Zoning Staff Report

Case Number: ZC-22-157

Zoning Map Amendment & Site Plan

PLANNED DEVELOPMENT
SITE PLAN
QUARRY FALLS
CITY OF FORT WORTH,
TARRANT COUNTY, TEXAS
AUGUST 2022
ZONING CASE # ZC-22-157

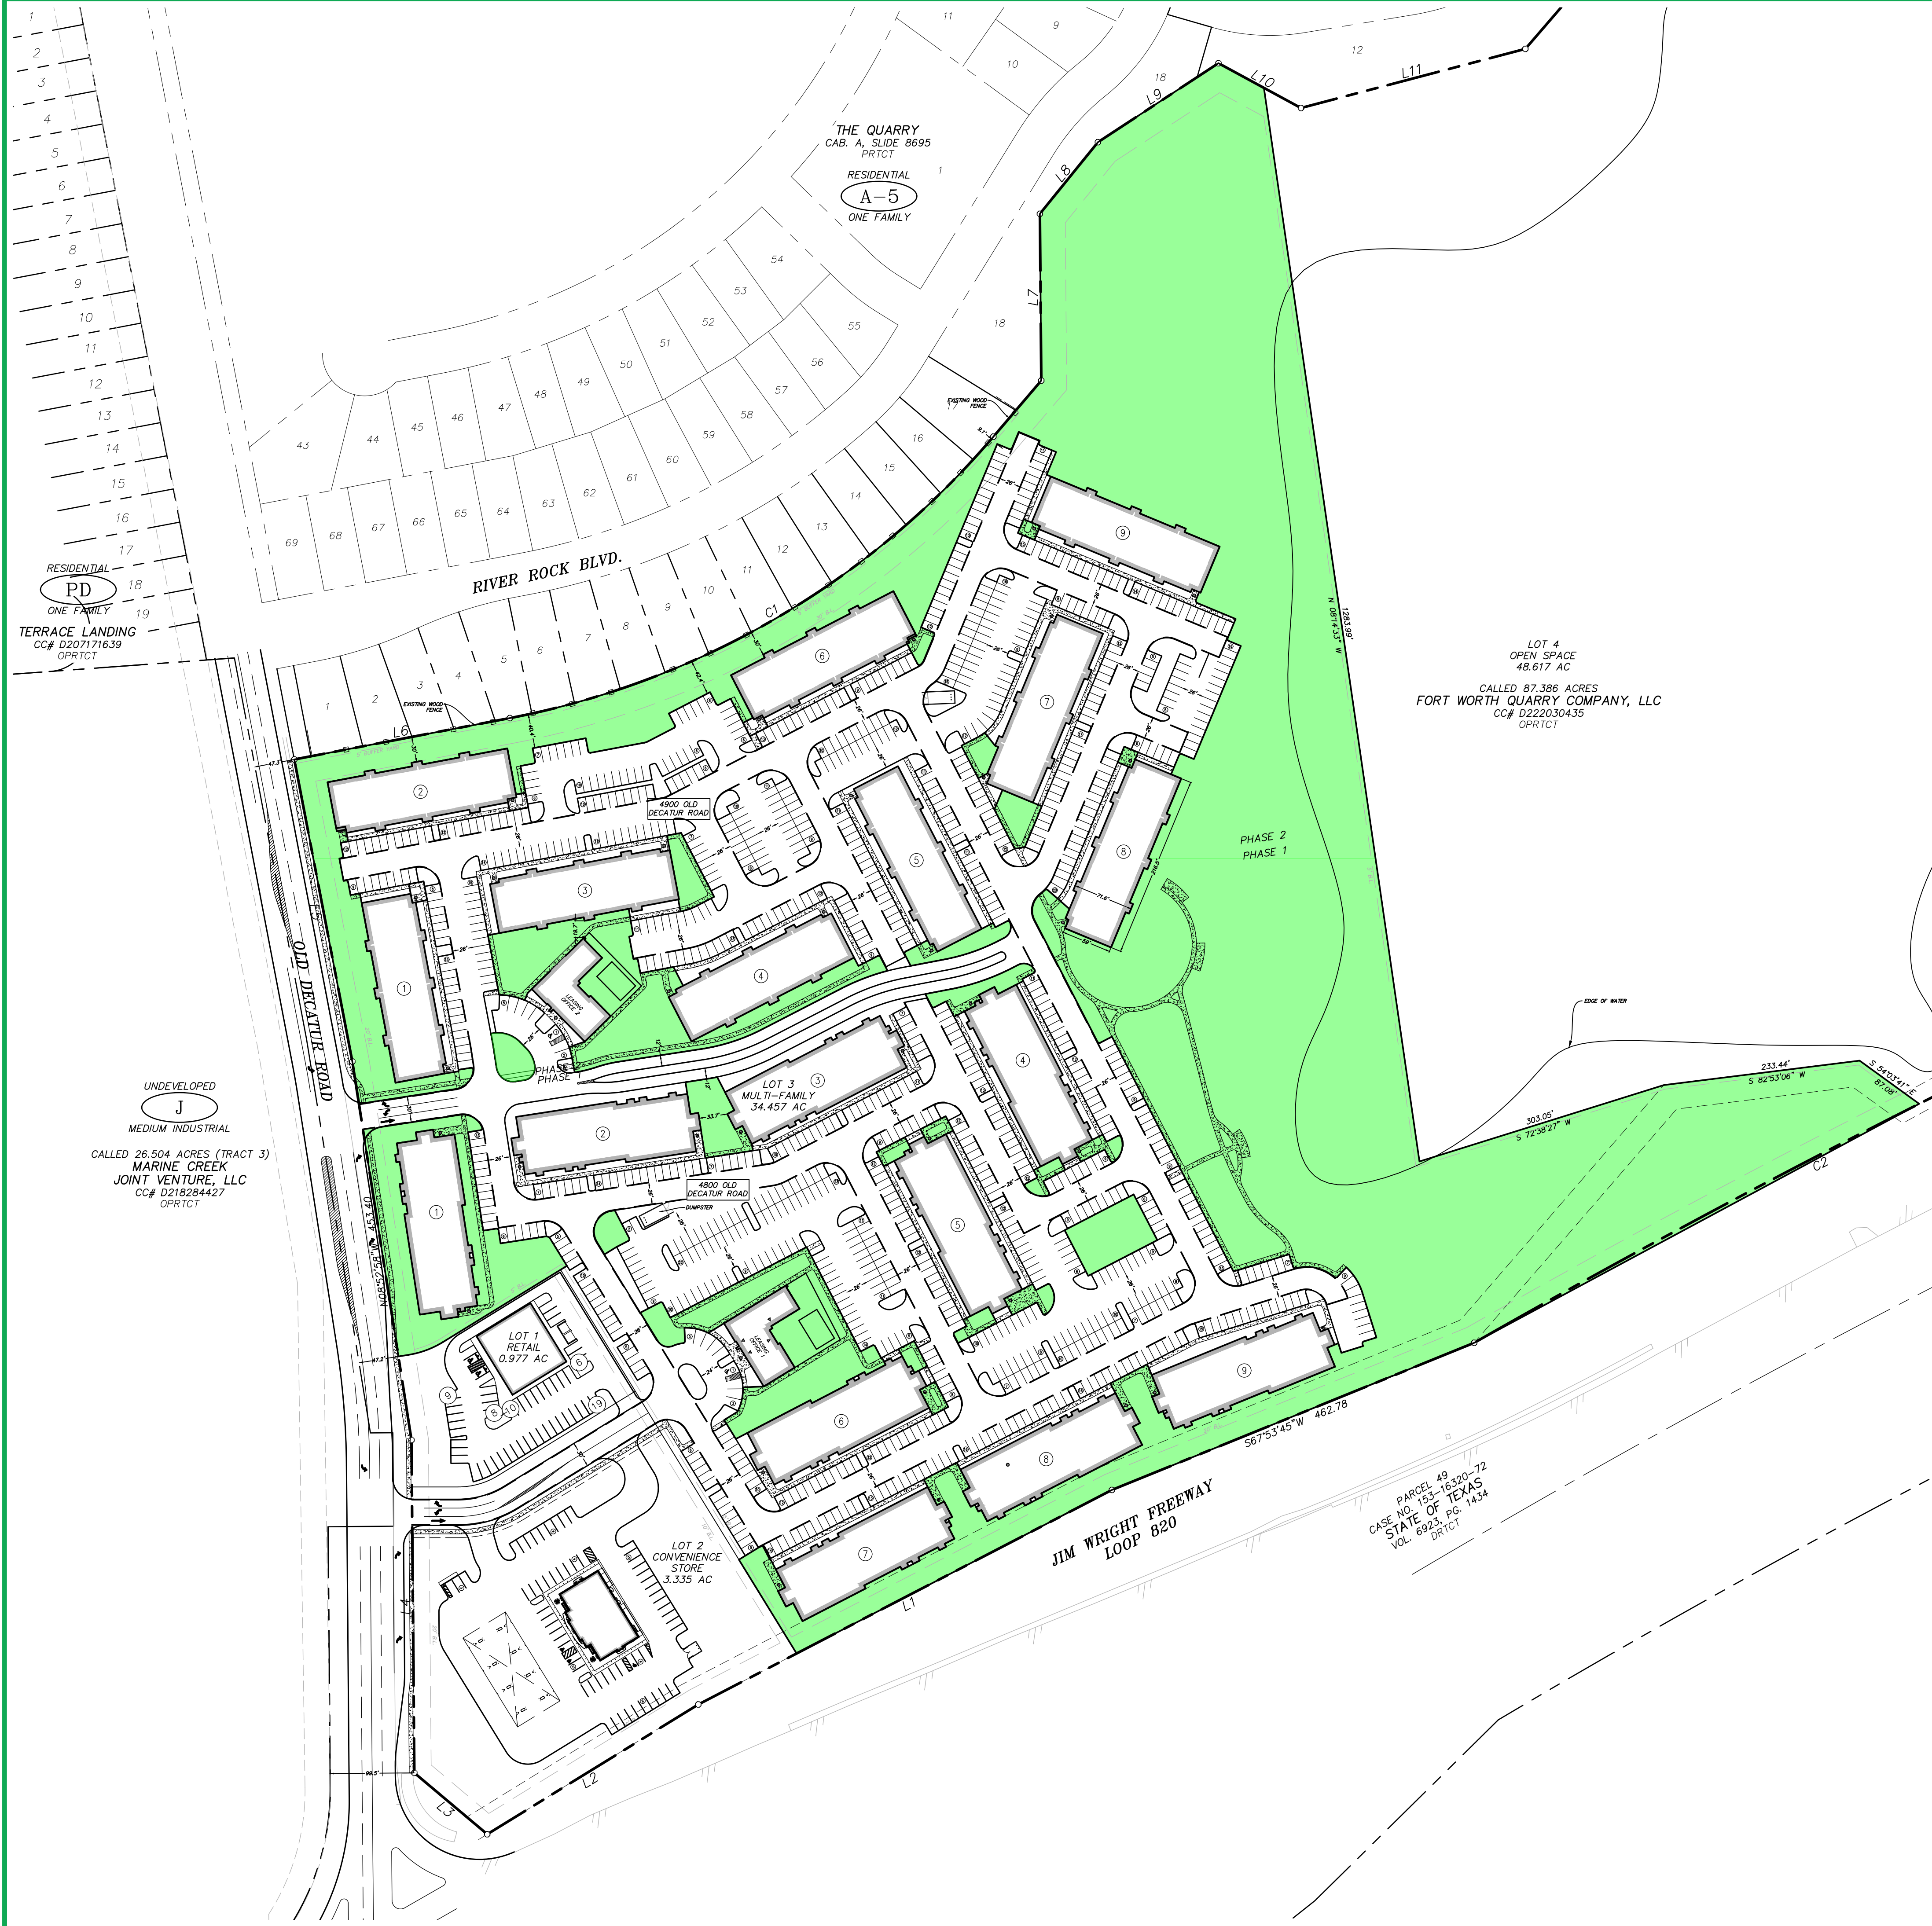
- Add case reference ZC-22-157 to both Sheets.
- Both sheets say “Sheet 1 of 2”.
- Missing Site Address (if no address – just use corner of intersection) label on both sheets.
- General note 3 on both sheets should reference Section 4.711.d.6.a in addition to Section 6.301.
- Building setbacks on the Site Data Table for Commercial Requirements should read: Front – 0’ (adjacent to arterial), Rear Yard – 15’ (adjacent to residential district), Side yard (interior) – 0’, Side yard (corner) – 0’.
- Add list of variances to Site Plan page showing close up of developed site, titled as “Development Standards”.
- 2 spaces project in front of building (northwest corner of multifamily site) need to be removed or relocated.
- Strike building height variance from listing (the development is the same as the “C” standard of 36’).

FYI: Emergency Access Easements and Public Access Easements providing access to the multi-family development will be named for addressing. All street names in the City of Fort Worth must be approved by the Fire Department and included within final plats.

FYI: Additional hydrants will be required to accommodate the following:

? 600 ft. (300 ft. radius) of space between hydrants along a direct horizontal line, and

? 500 ft. hose lay distance to all points of building.

FYI: Hose lay must be provided to all exterior portions of each building within 150', measured in a 5' wide unobstructed path around the building. 300' MAY be allowed for buildings having fire sprinkler systems.

Water and sewer along full frontage required.

(All comments addressed as of 10/3)
